Voltage control gear

in relation to halogen filament light sources

IEC position

GRE 67

Example H7 low beam reduced flux 13.2V (1500lm) vs 12V(1100lm)

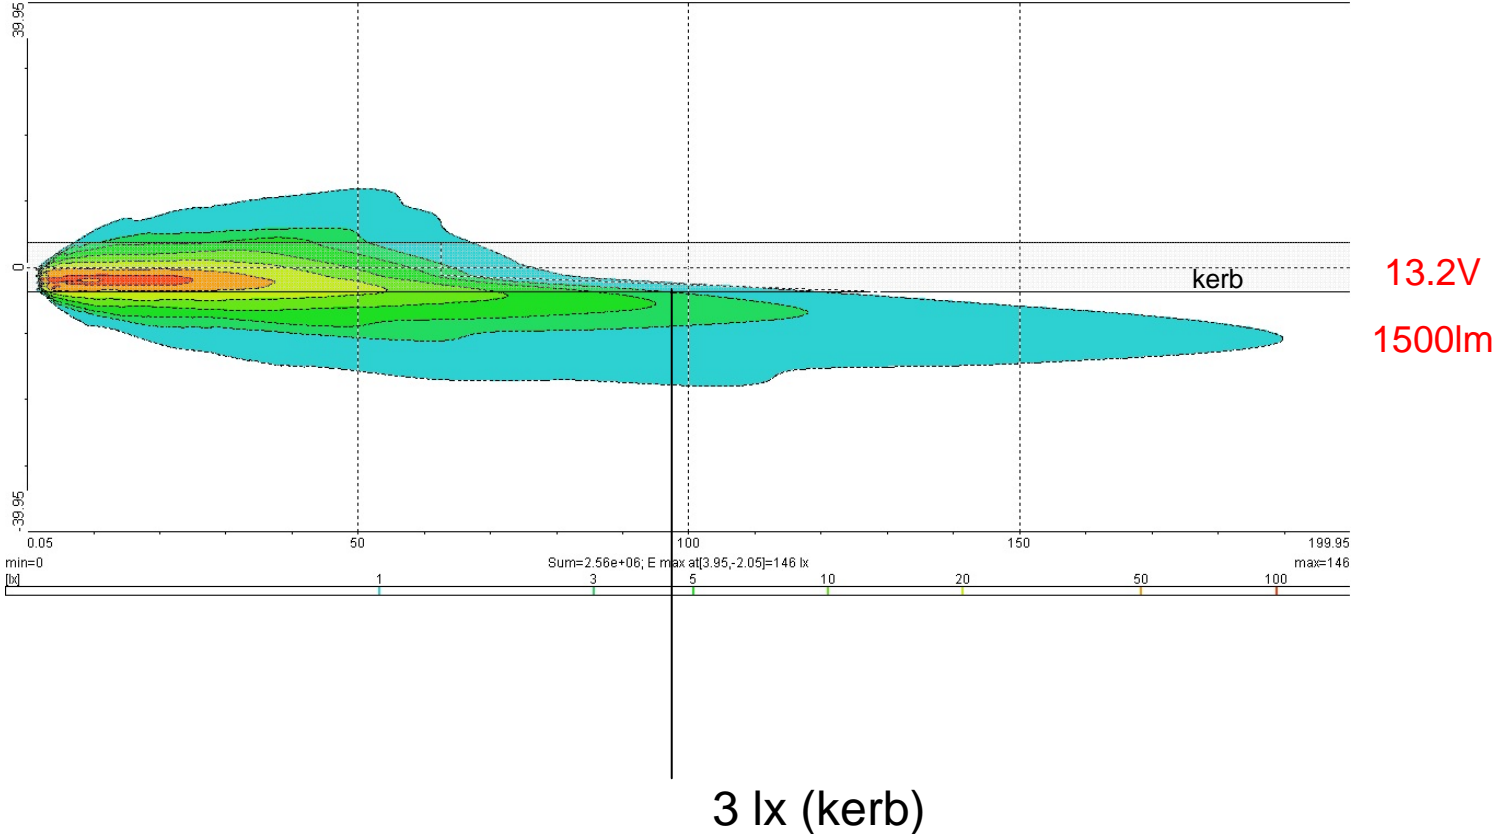
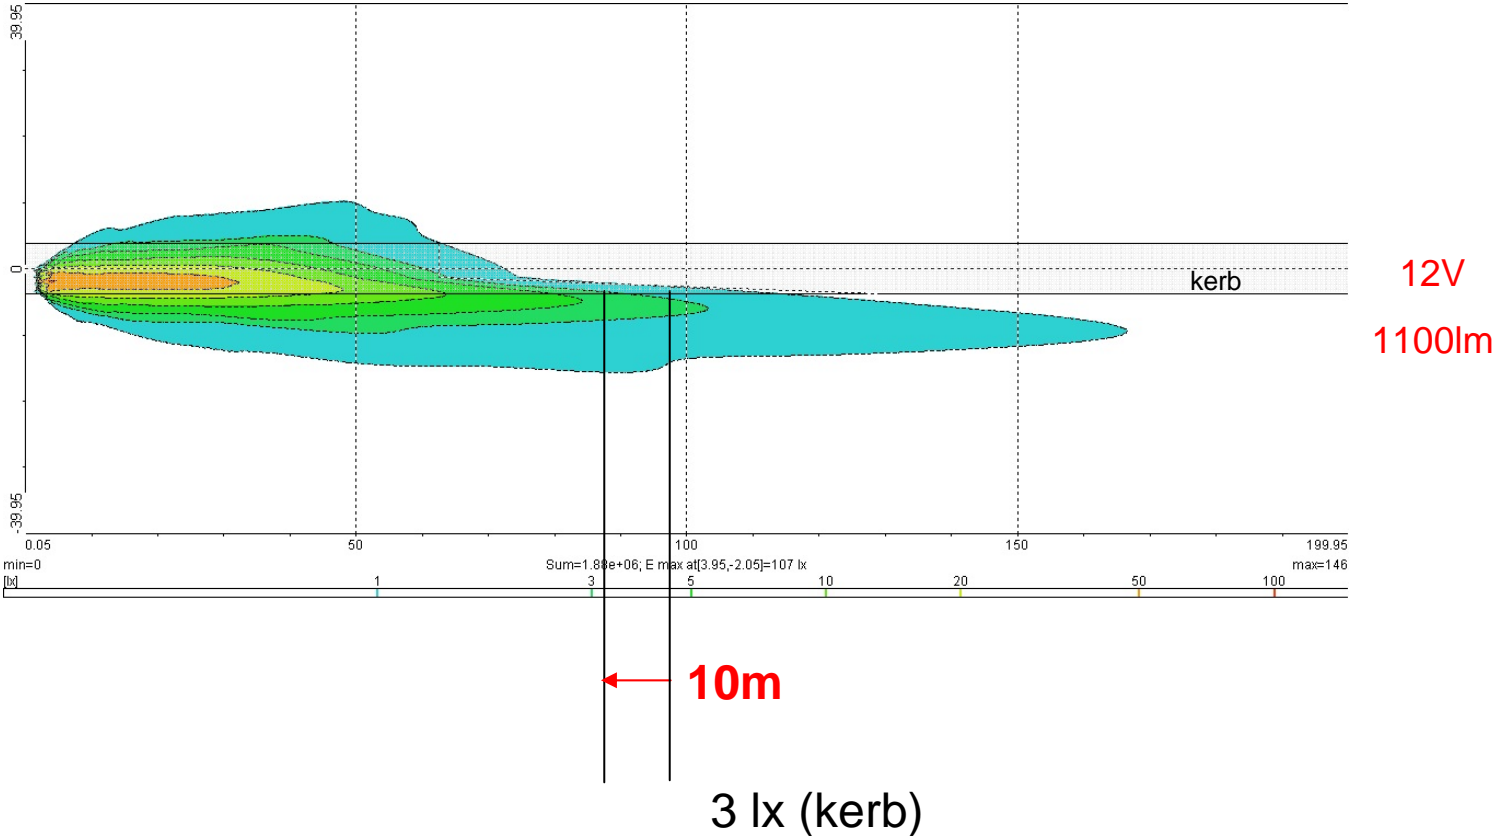
- No clear correlation between
 - the voltage applied to the halogen light source; and
 - the voltage applied at the time of homologation
- Proposal allows continuous low voltage
- Voltage variation has consequences for
 - the correct physical operation
for physical aspects, the effects of voltage variation are fairly well known
 - the chemical operation
the chemical effects cannot be generally specified
- Low voltages to halogen filament lamps has consequences for road-usage:
 - Less light on the road
 - Early failures
due to disturbance of the flow of gas and filament particles
 - Glare
due to filament distortion since filament particles evaporate and land elsewhere

IEC additional proposal(s) to GRE/2012/12

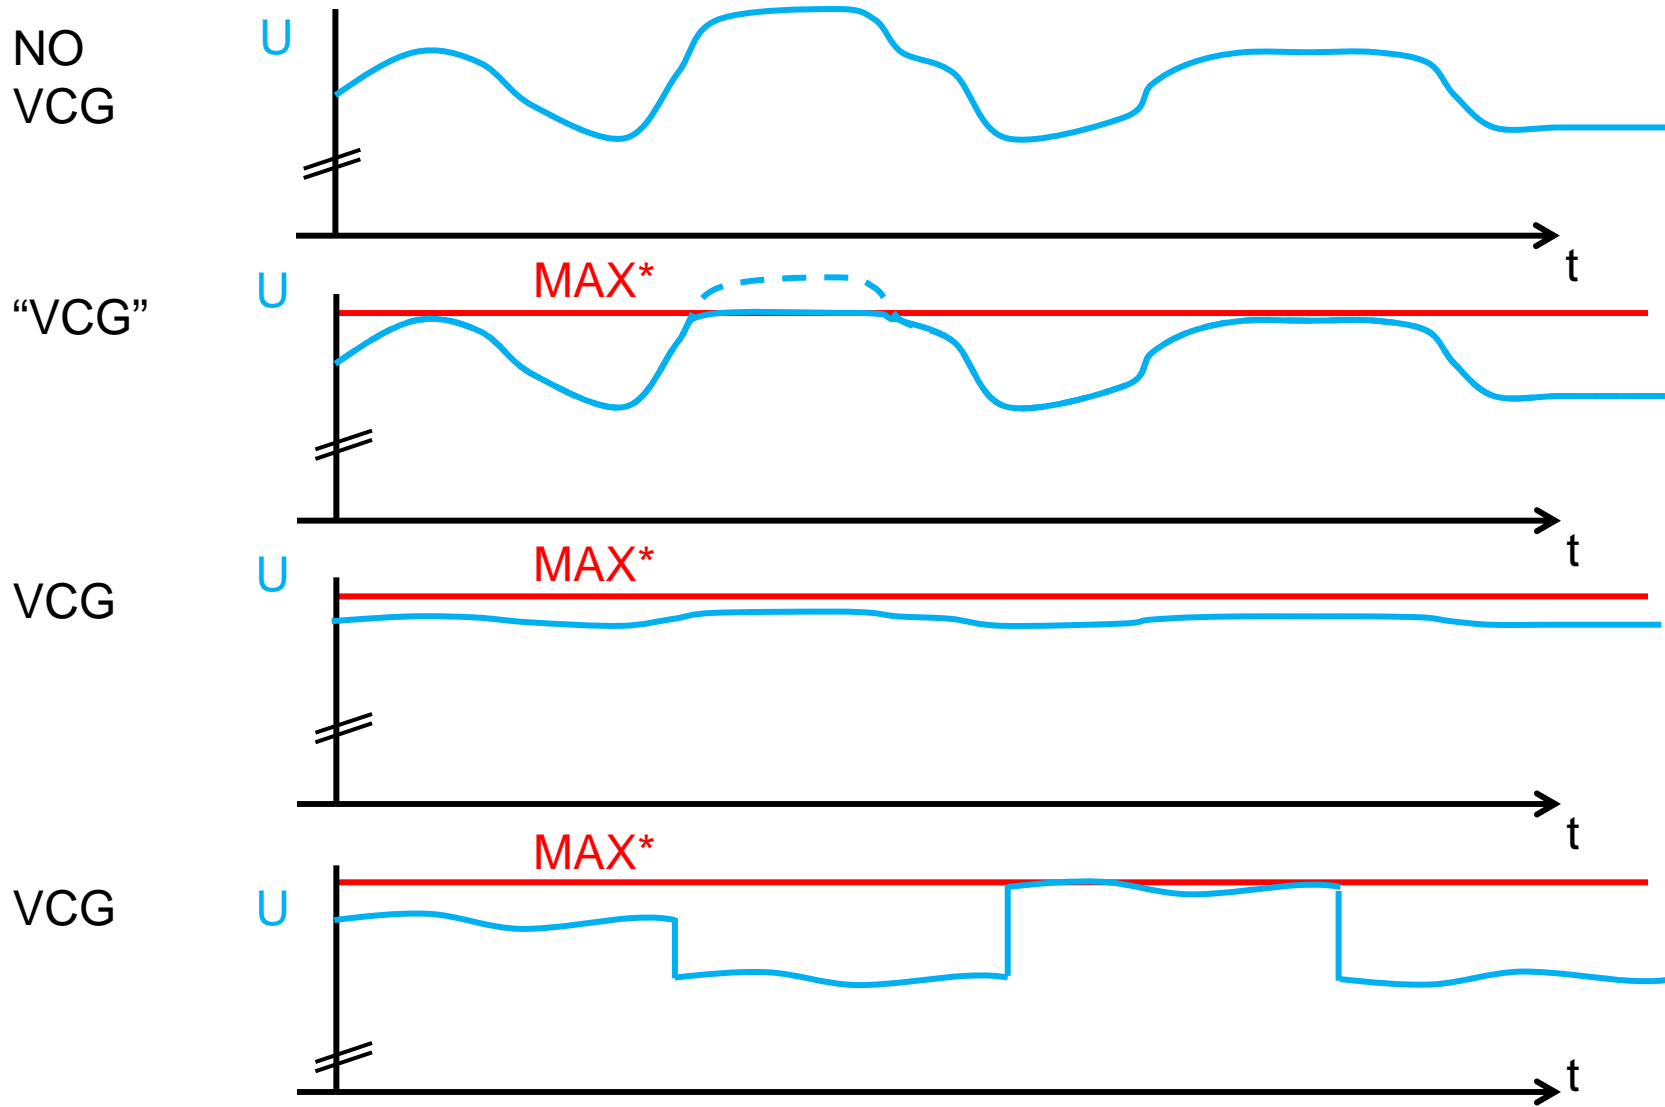
- To allow VCG in R112
 - No dimming
 - No step-up conversion
 - Maximizing voltage

- To complete R48, paragraph 5.27, in case of any voltage control gear
 - Add a requirement to the minimum voltage offered to voltage control gear
 - No spikes taken into account, but :
 - As an effective voltage determined over quite a long period of time

Insert new paragraph 5.3.1.3., to read:

“5.3.1.3. In case of electronic light source control gear(s) being part of the headlamp, the electronic light source control gear(s) shall convert the voltage at the terminals of the affected filament light source only if the input voltage at the terminals of the electronic light source control gear exceeds the specified test voltage by more than 3%.

In these cases, the voltage at the terminals of the affected light source shall be stabilized within $\pm 3\%$ of the relevant test voltage(s) as specified in Regulation No. 37.”

Currently Regulation No. 48

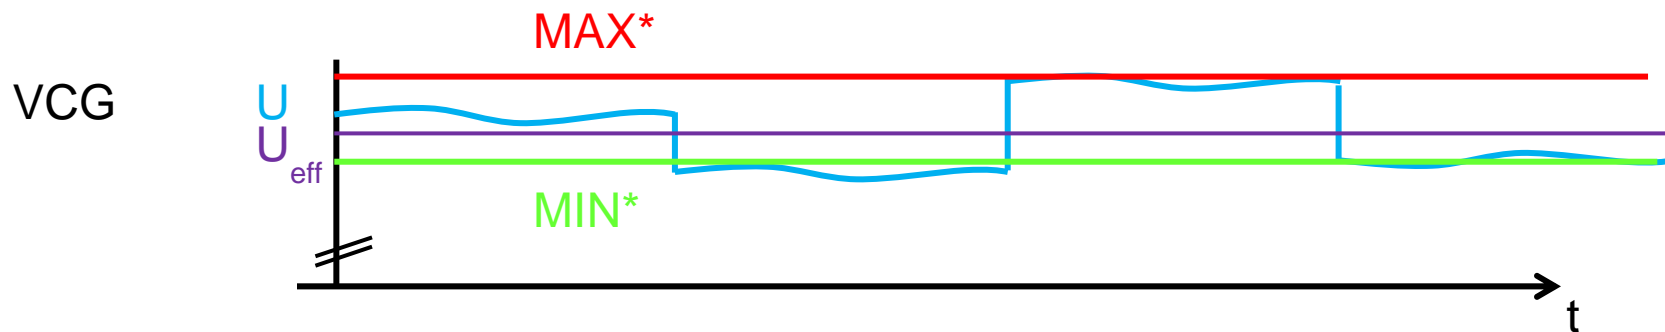
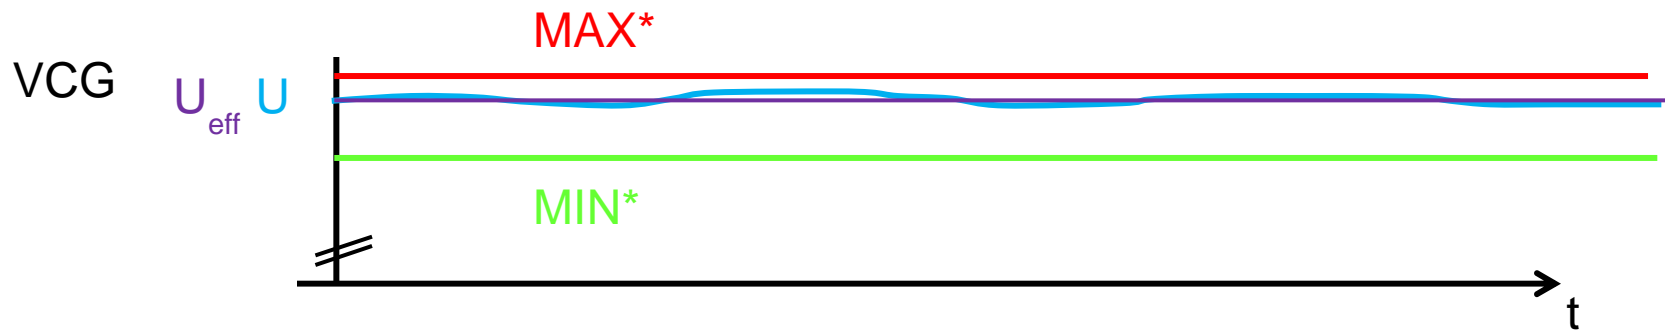
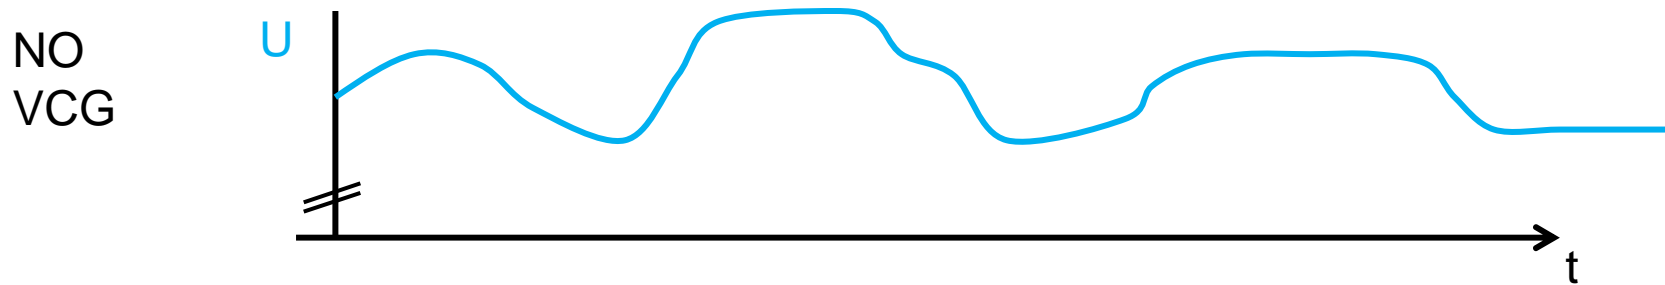
A constant low voltage should be avoided

Renumber paragraph 5.27.4 into 5.27.5 and insert a new paragraph 5.27.4:

“5.27.4. In the particular case where devices equipped with a filament light source produce the principal or basic passing beam in conjunction with electronic light source control gear, the effective voltage determined over [20 minutes], at the terminals of the filament light source when the electrical system of the vehicle is in a constant voltage operating condition according to paragraph 5.27. shall not deviate from 6.3 V (6 Volt-Systems), 13.2 V (12 Volt-Systems) or 28.0 V (24 Volt-Systems) by more than minus 3%. Additionally, in the case of filament light sources for which more than one test voltage is specified in Regulation No. 37 this deviation shall not be more than minus 3% from the lowest value of these test voltages that are being applied in the device.”
